ENGINEERING CHANGE NOTICE

1. ECN 166756

3. Originator's Name, Organization, MSIN, and Telephone No. C. D. Delaney, Geosciences Group, H4-56, 6-9235				4. Date 2/28/92
5. Project Title/No./Work Order No. 216-B-3 Pond/R41AB		6. Bldg./Sys./Fac. No. 216-B-3 Pond System		7. Impact Level 2

12. Description of Change This supplement to the 216-B-3 Pond System groundwater quality assessment plan addresses placement of two monitoring wells to be installed in 1992 under the RCRA program per M-24-27.

Figure 1. Current Groundwater Monitoring Network for the B Pond System.

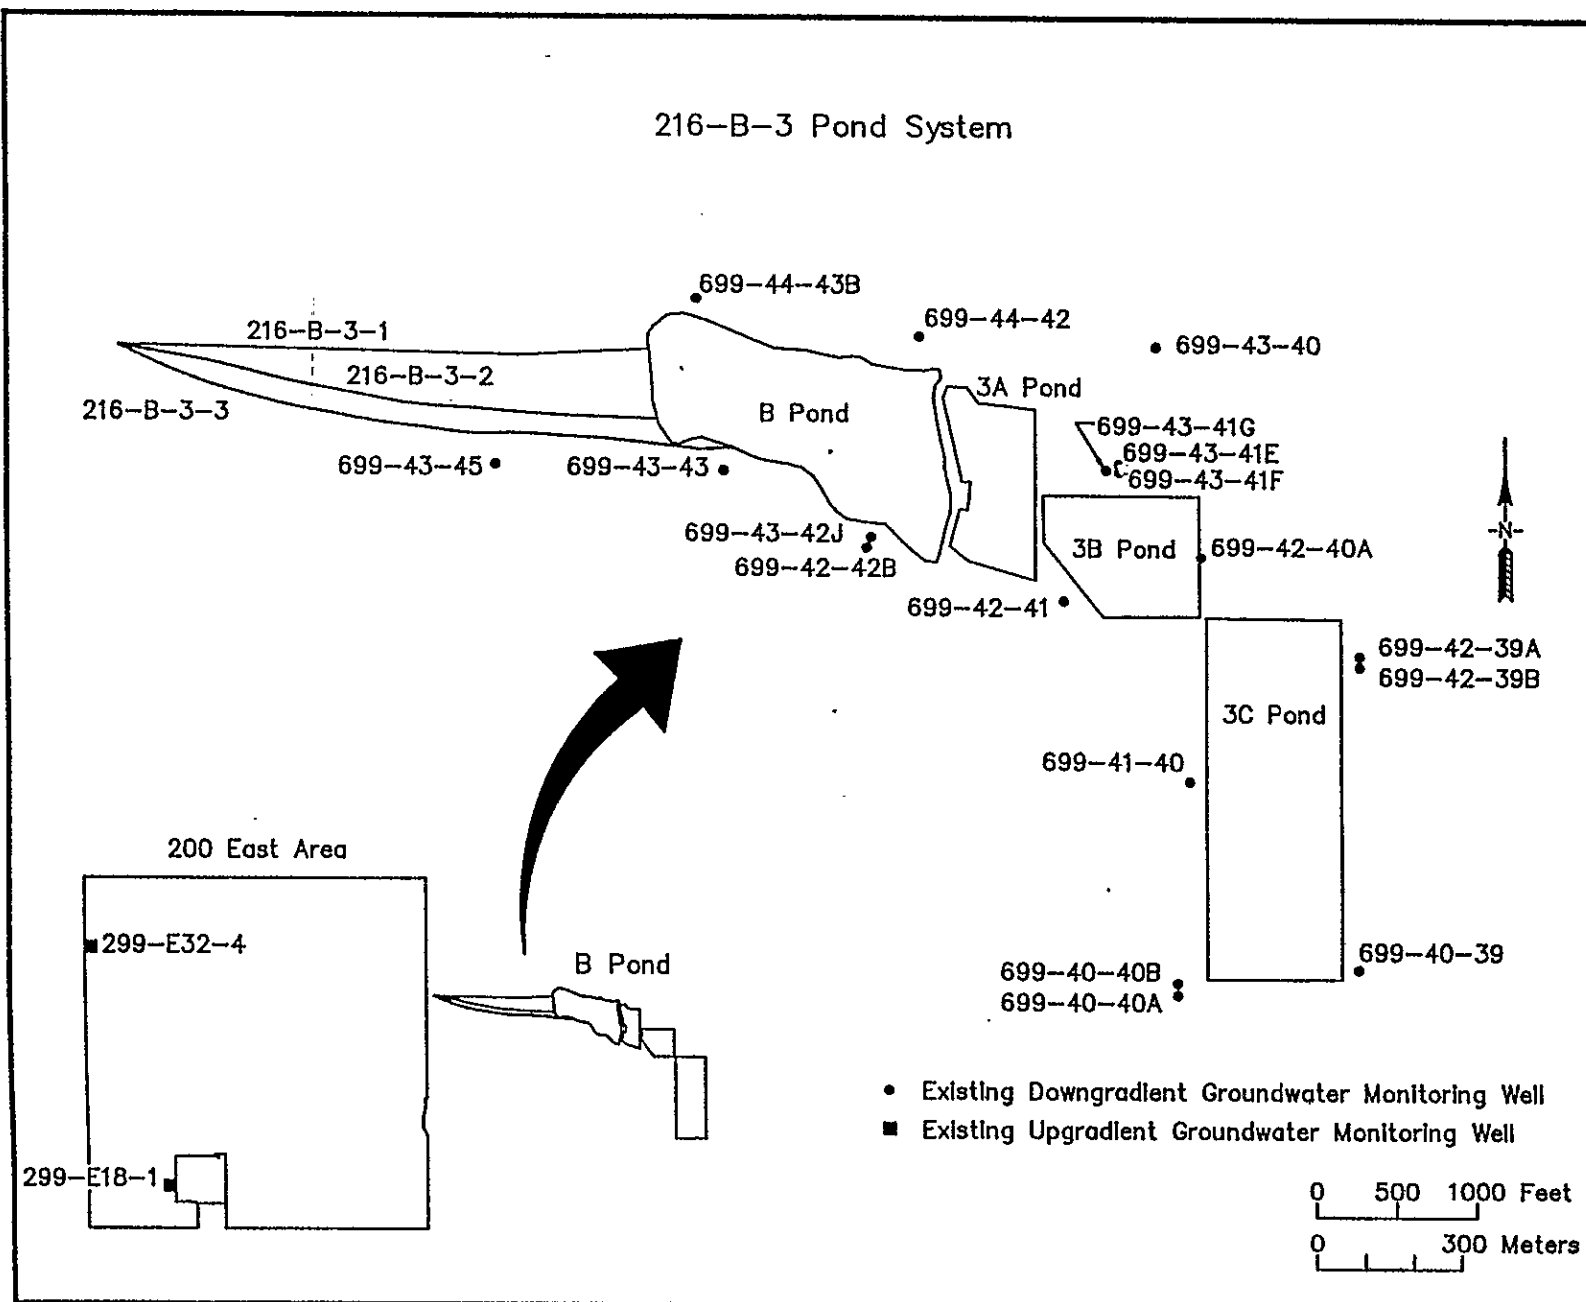
The configuration of the ponds and the locations of the current groundwater monitoring wells for the B Pond system are shown in Figure 1. The main pond and three lobes are considered to have adequate shallow monitoring well coverage with a total of 18 wells located around the main pond and lobe boundaries. The main lobe has five wells located around its perimeter (699-44-43B, 699-44-42, 699-43-43, 699-43-42J, and 699-42-42B). The 3A and 3B ponds have monitoring well coverage on the northern, eastern, and southern boundaries (699-44-42, 699-43-41E, 699-43-41F, 699-43-41G, 699-42-40A, and 699-42-41). The 3C pond has seven wells located around the perimeter (699-40-39, 699-40-40A, 699-40-40B, 699-41-40, 699-42-39A, 699-42-39B, and 699-42-40A).
